Docket No. 50-261

RE: H. B. ROBINSON UNIT NO. 2

Enclosure:
Burnup-Dependent Correction
for Fission Gas Release
Models

FIGURE 1

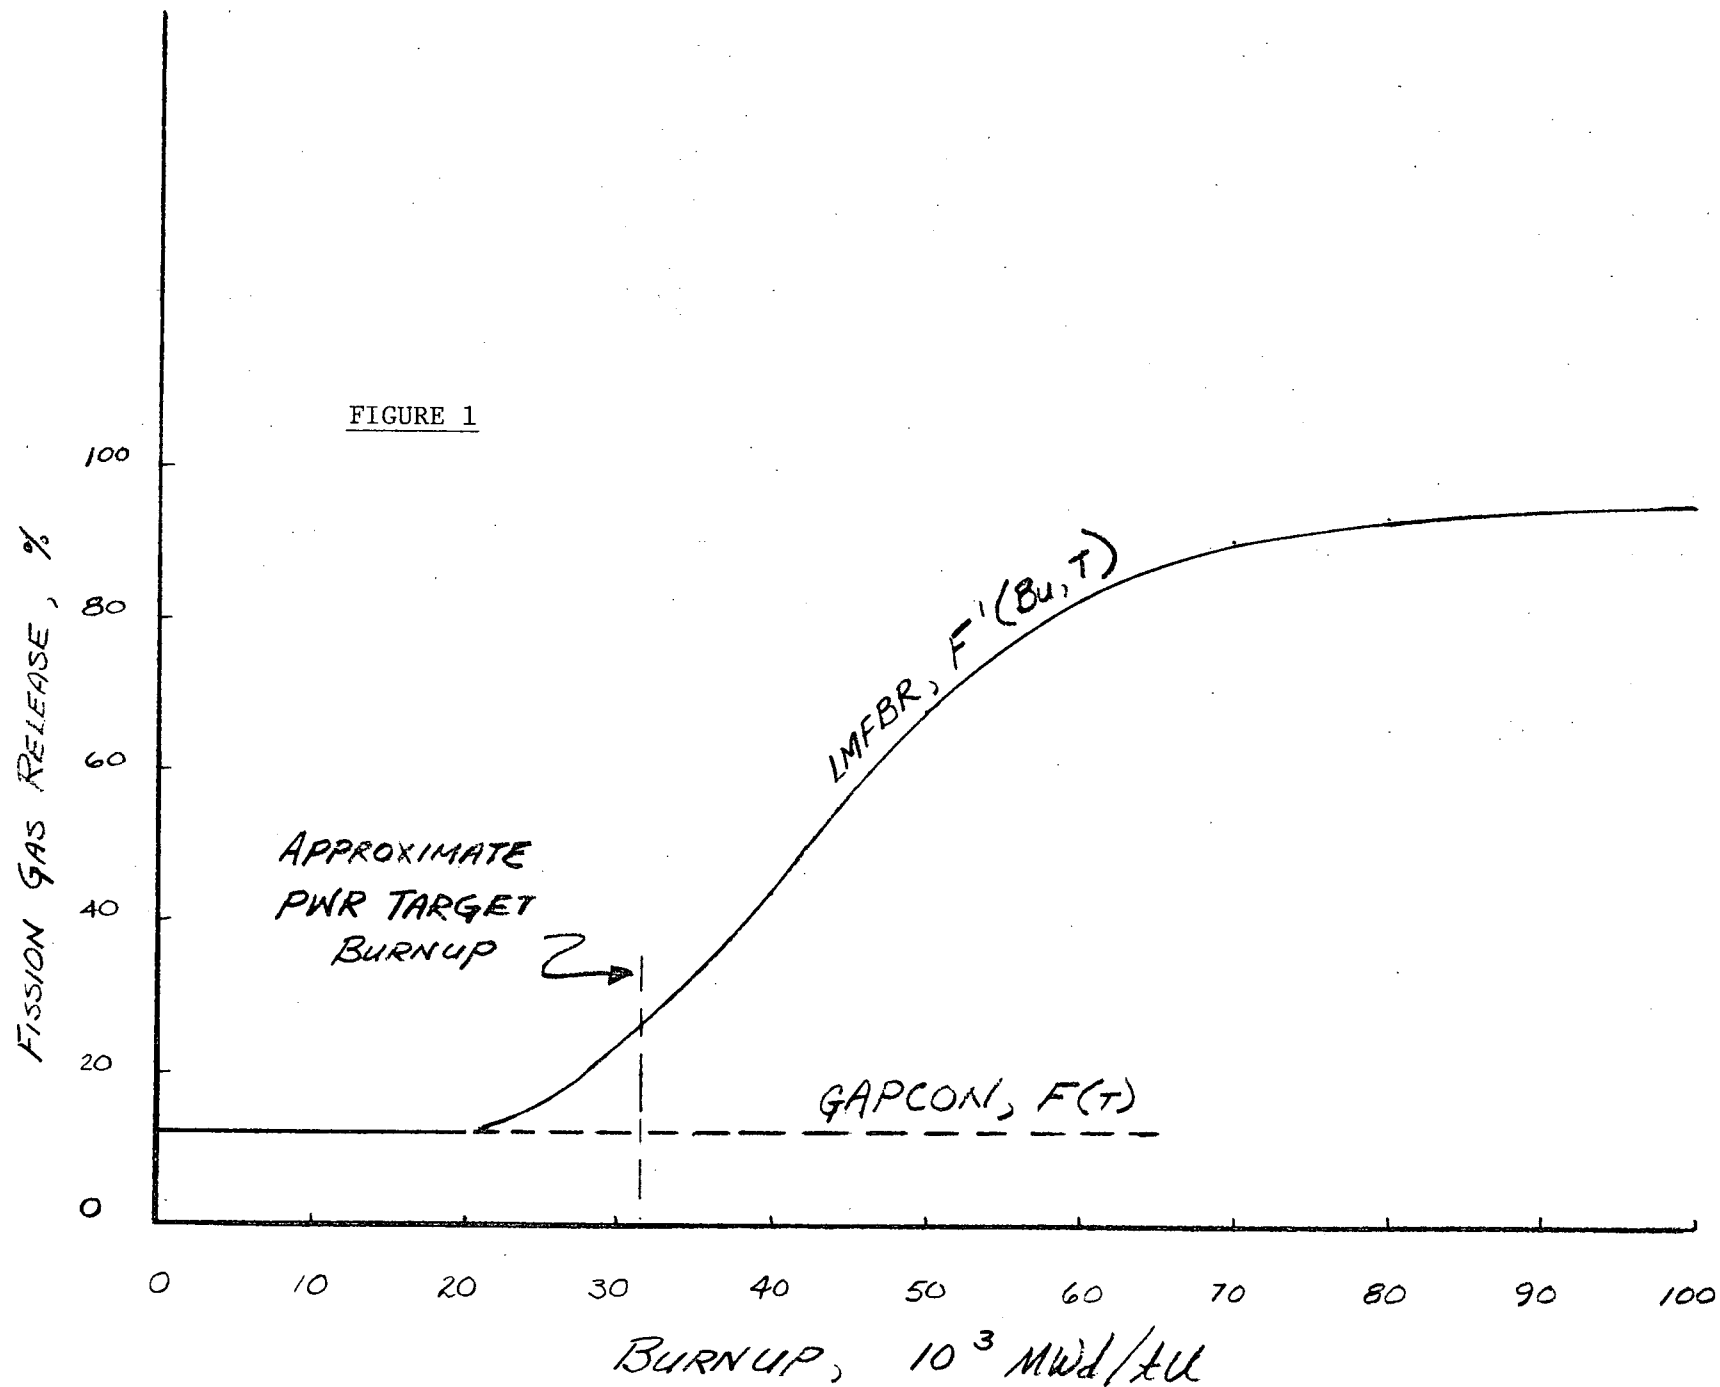
Figure 1 shows schematically how this correction would be applied to the GAPCON gas release model, which is independent of burnup. In the event an existing model contains a burnup dependence, $F(T)$ would be the predicted release fraction under the temperature conditions of interest, but with the burnup variable set equal to 20,000 MWd/tU.
